20120-01-001

**Proposed Wind Farm at
Castlebanny, Co. Kilkenny**

ROAD SAFETY AUDIT STAGE 1 / 2

December 2020

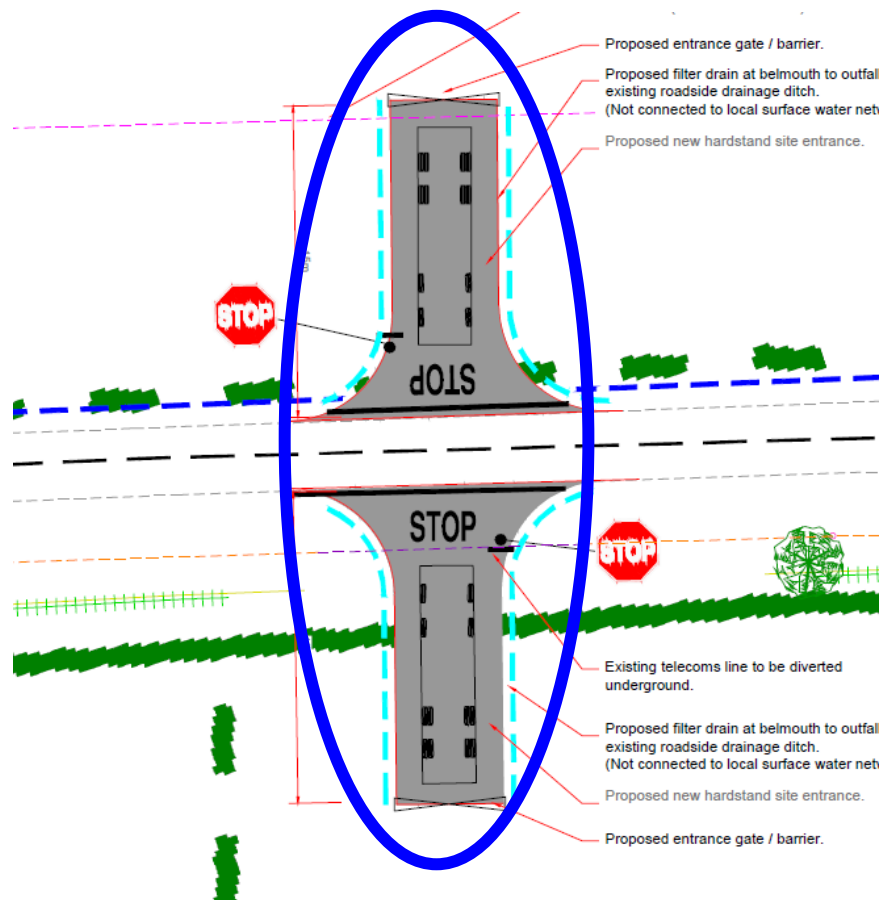
The swept path analysis at the proposed access to the wind farm suggests that the access cannot adequately cater for a HGV entering and exiting the development at the same time. A delay in a HGV turning into the development from the R704 may lead to a rear-end collision.

Ensure the proposed access can adequately cater for HGV's entering and exiting the site access simultaneously.

Drawing No.: 10730-2050 D01

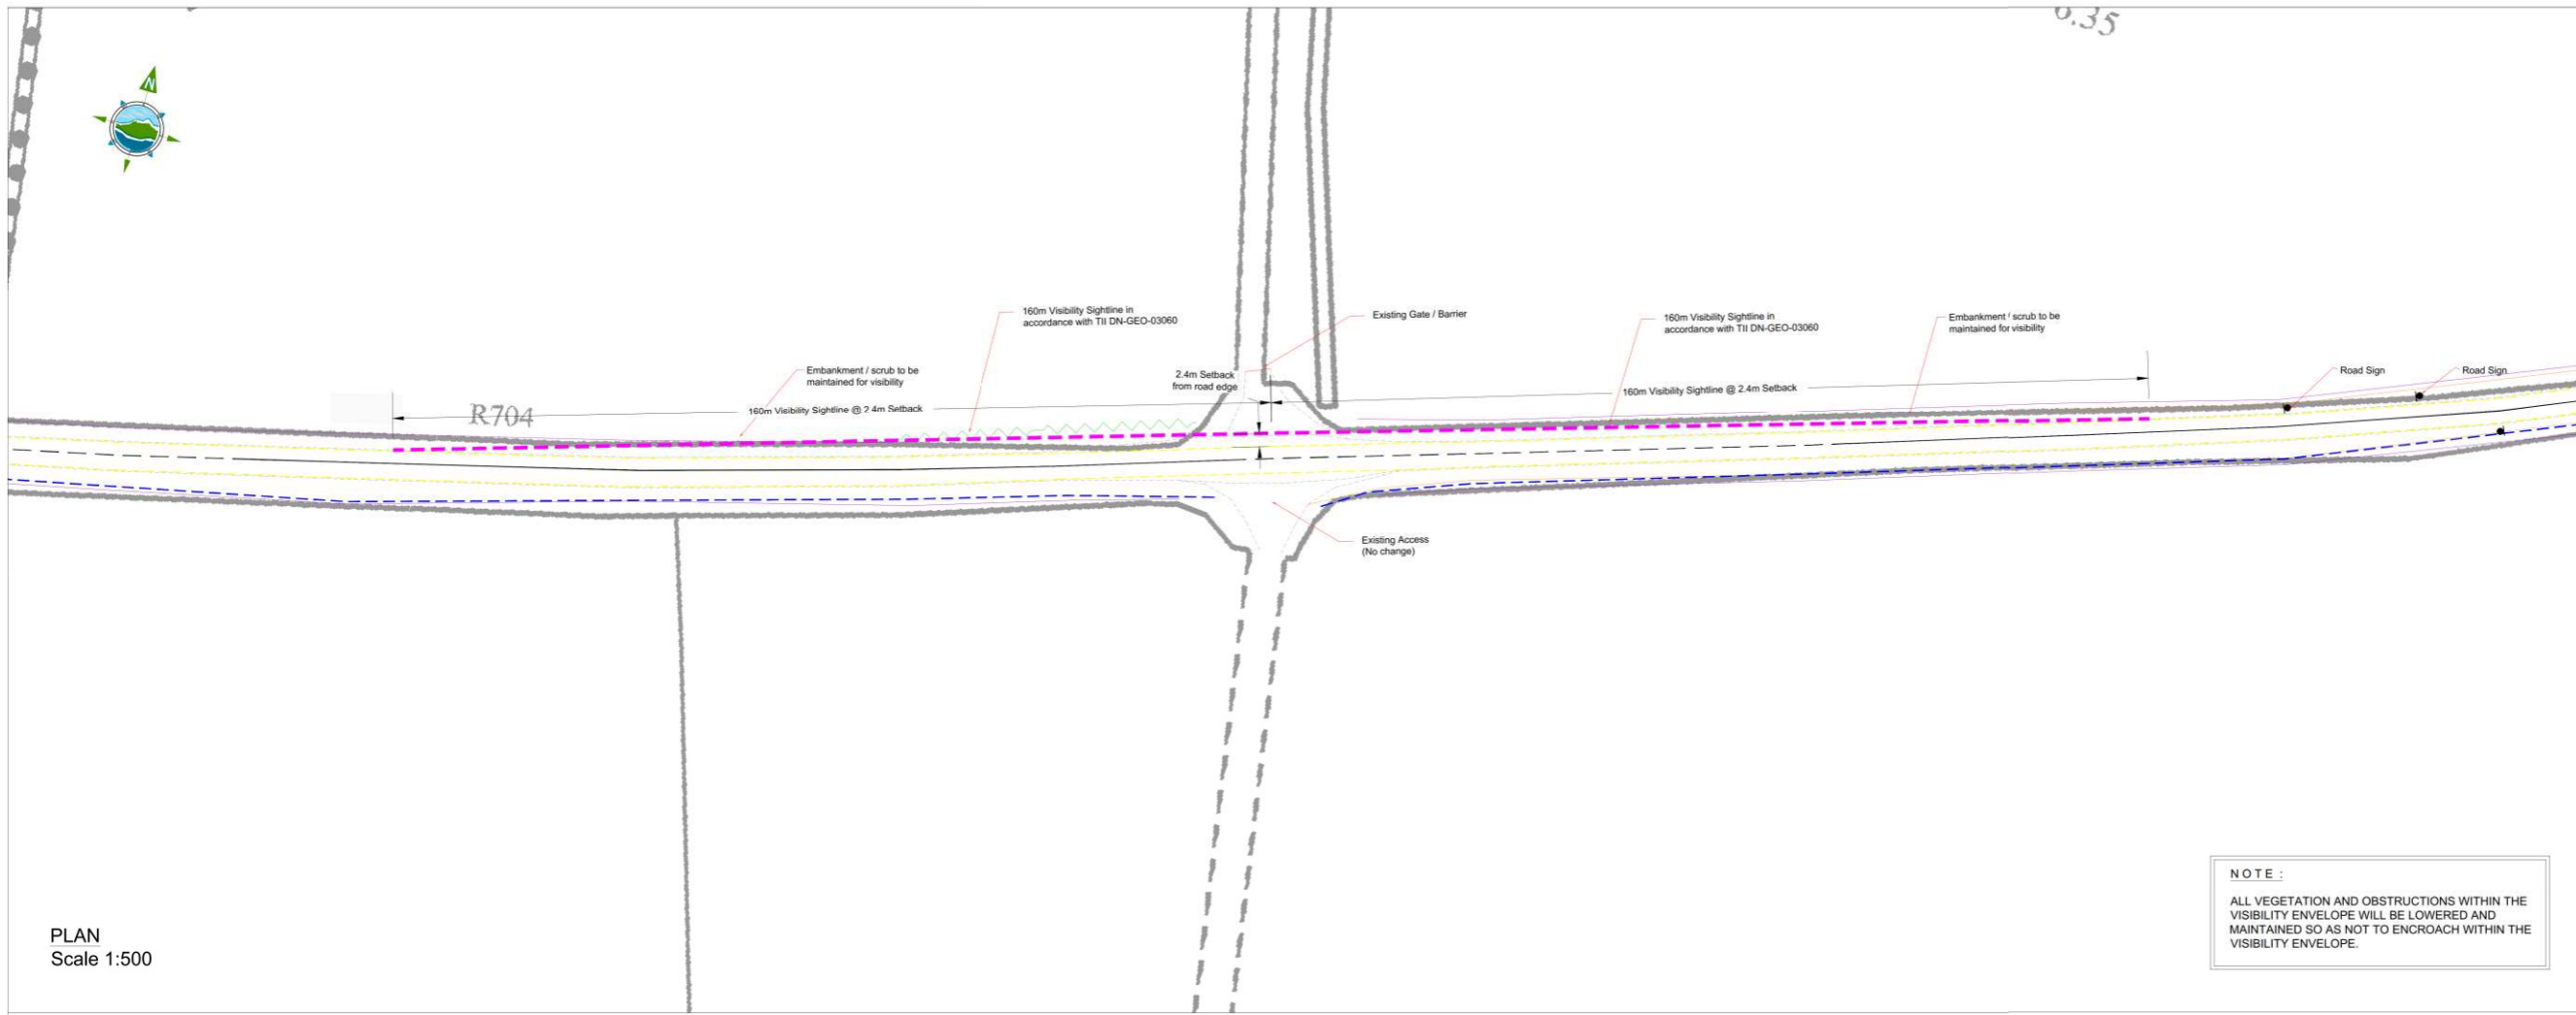
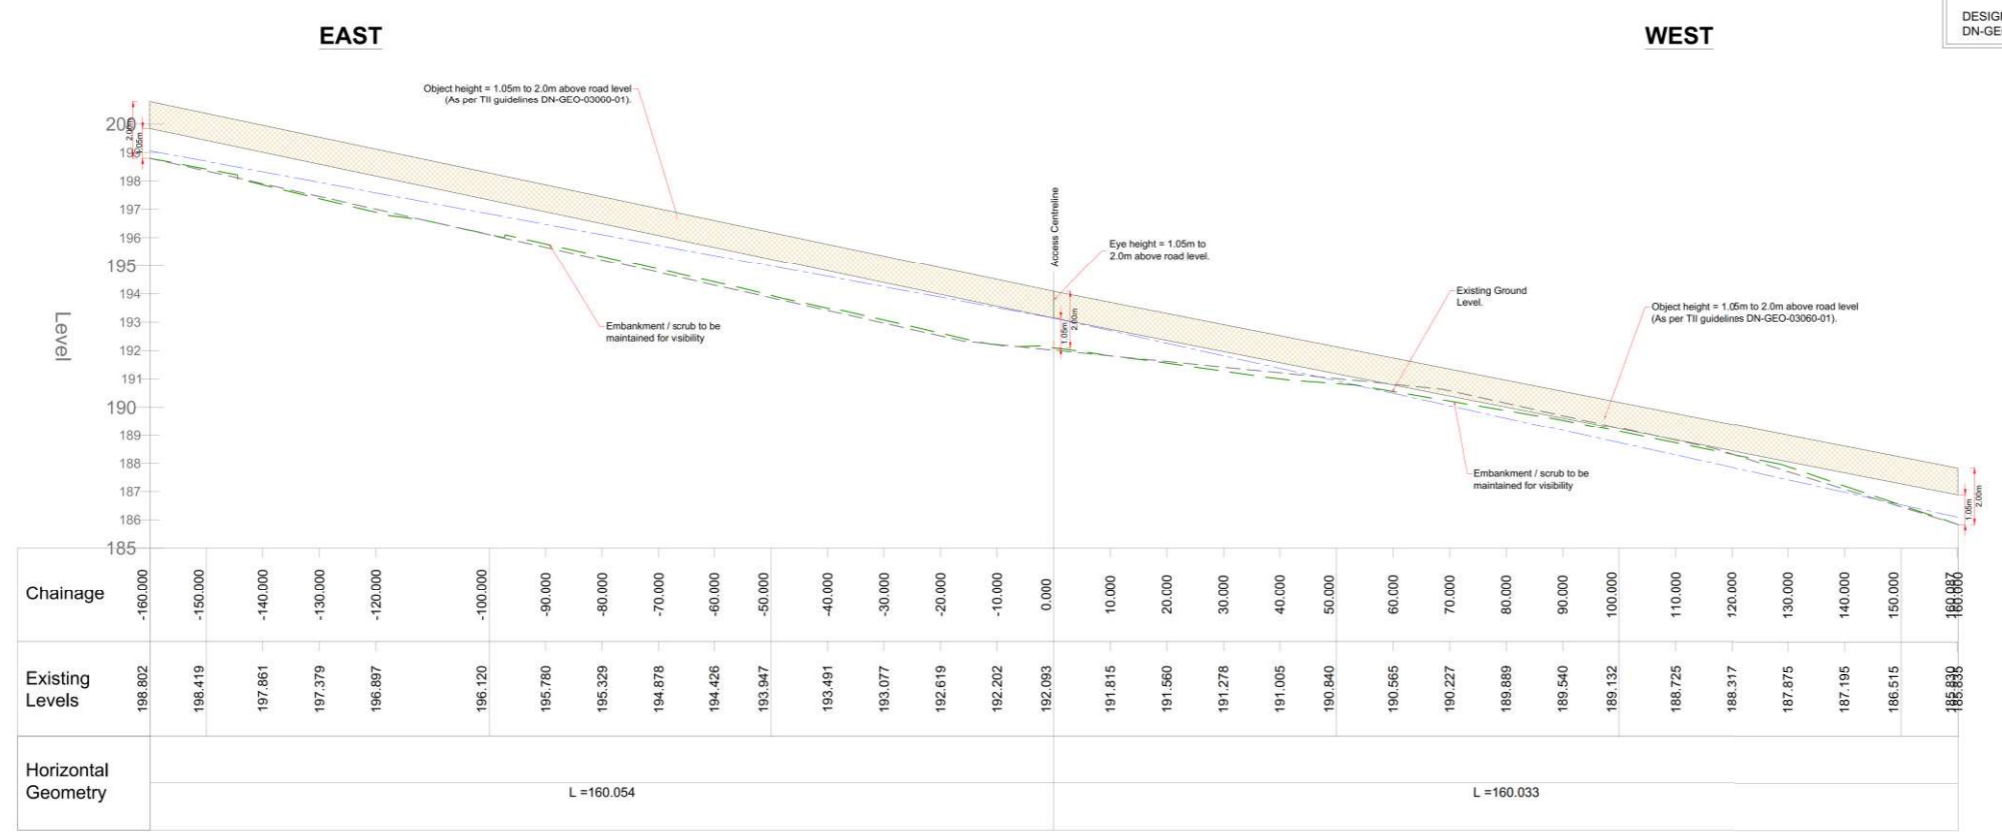
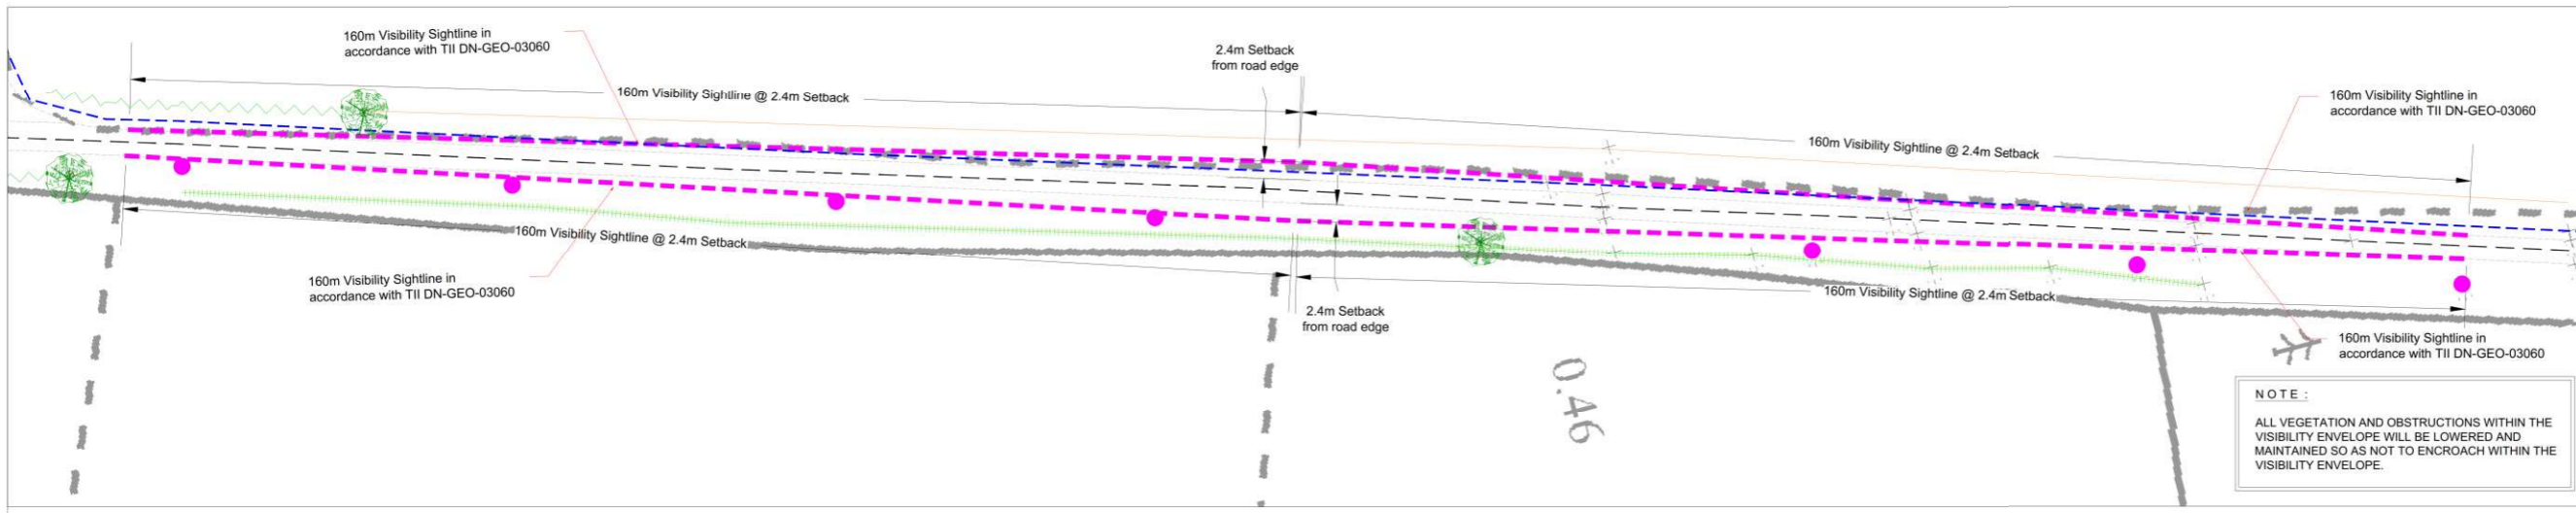
There is an existing dip in the vertical alignment located on the western side of the R704 carriageway. Visibility splays at the proposed access to the wind farm may be restricted by the vertical alignment of the R704 regional road. A lack of adequate visibility at the proposed access may contribute to a side impact collision at the access.

Ensure adequate horizontal and vertical visibility splays are provided at the proposed access onto the R704 regional road.

Drawing No.: 10730-2053 D01

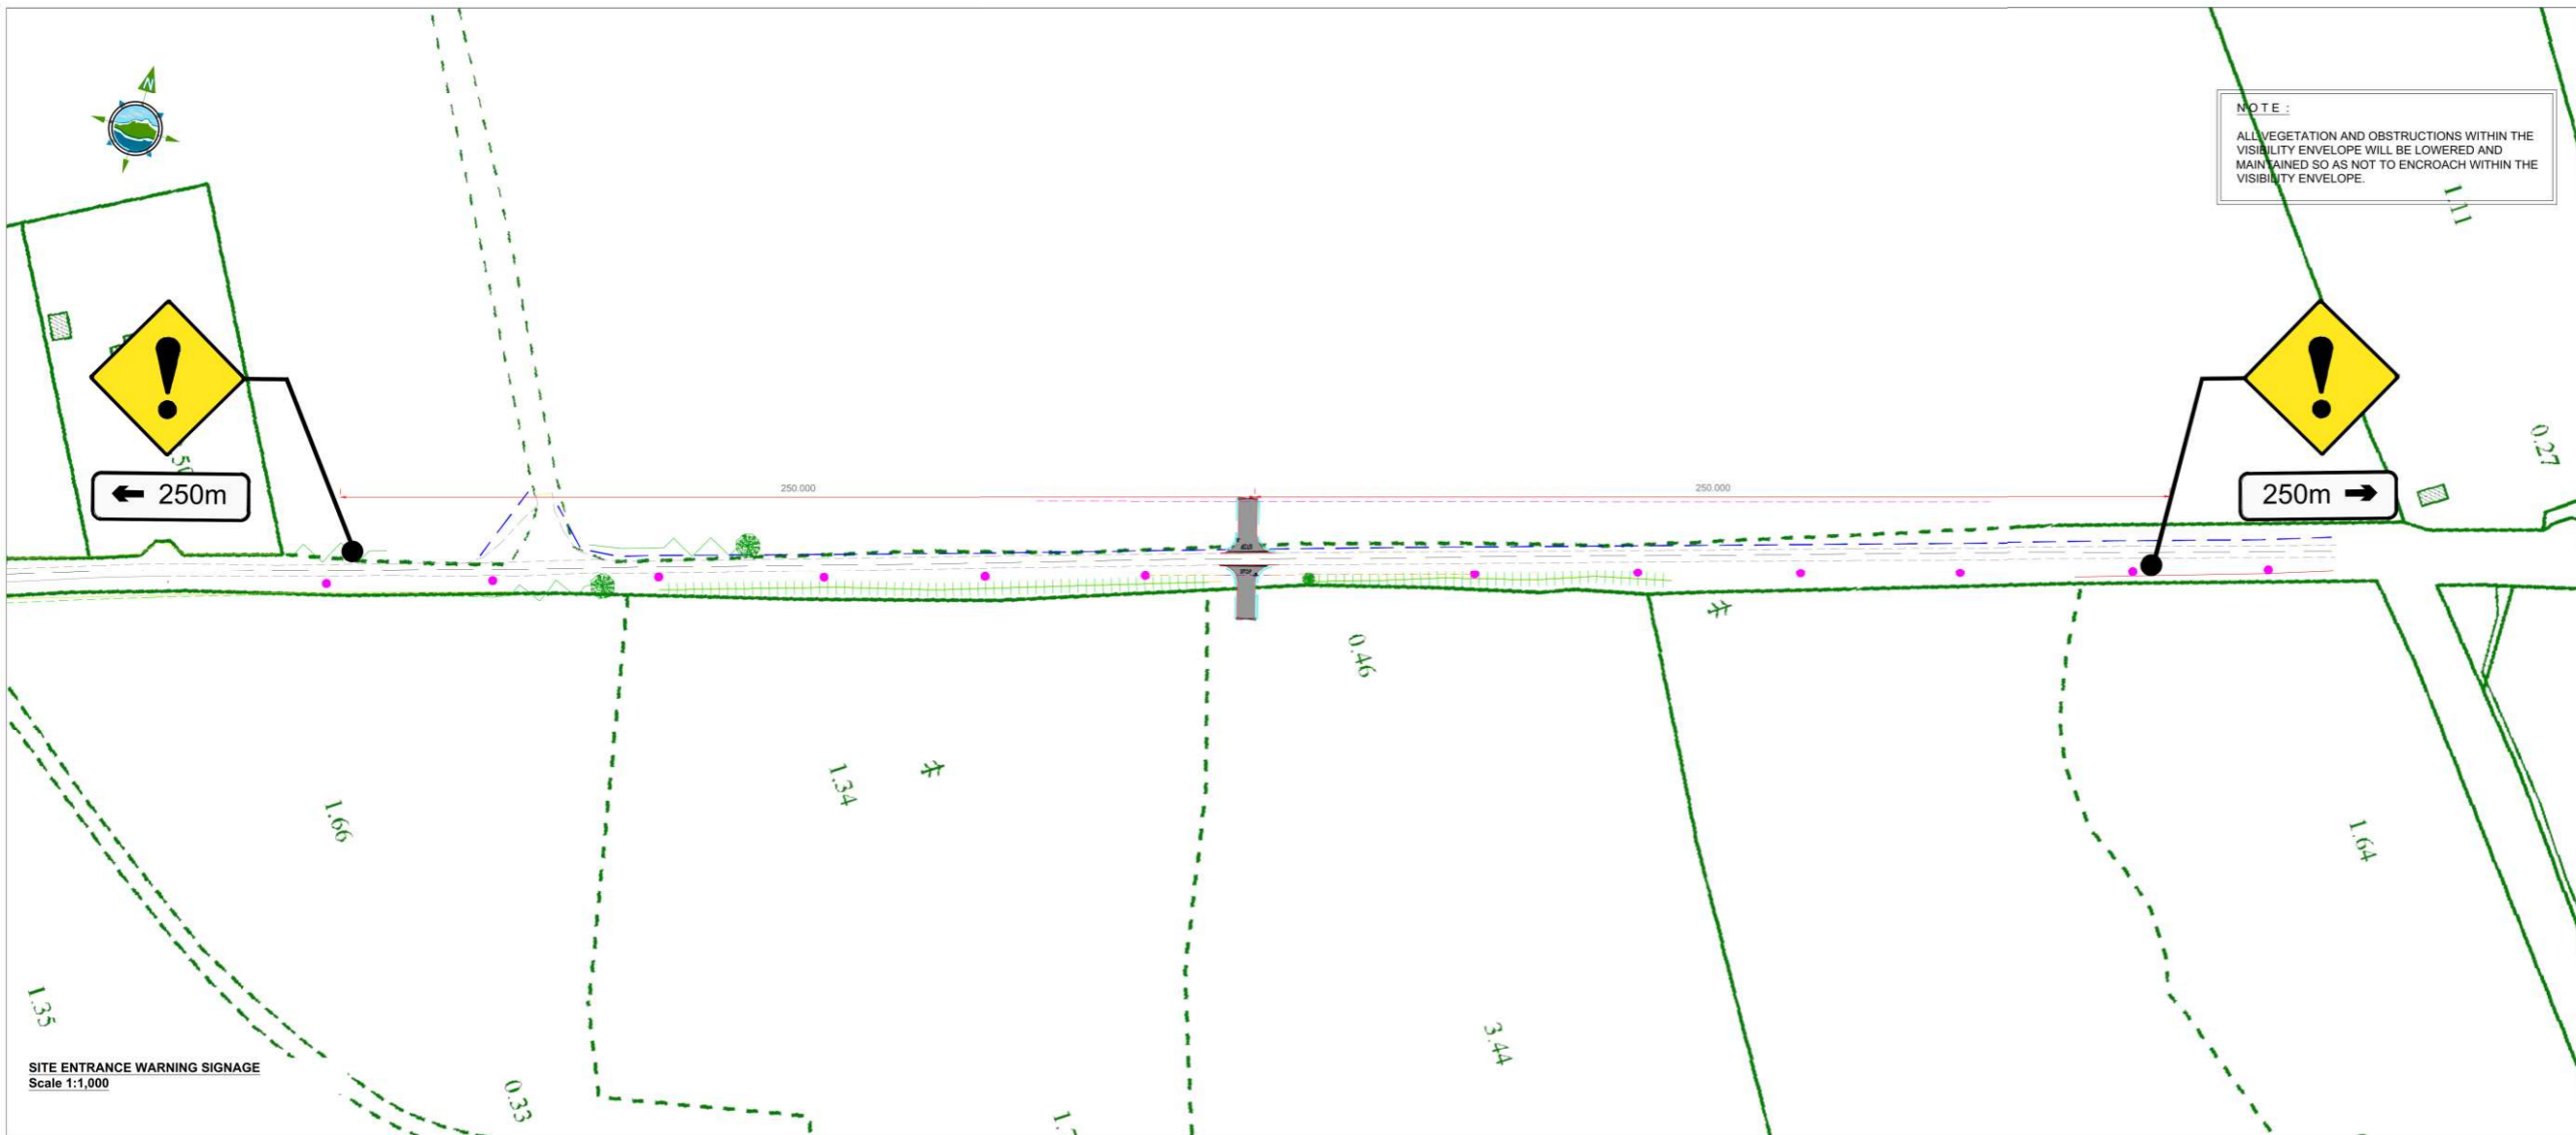
At the proposed crossing point located on the local road the proposed internal access road is approximately 5m wide. The proposed width may not adequately cater for opposing HGV's passing one another at the

access points. A delay in a HGV entering the access points may lead to a side impact collision with a vehicle on the mainline.

Ensure adequate width is provided at the access points to cater for opposing HGV's to pass one another.
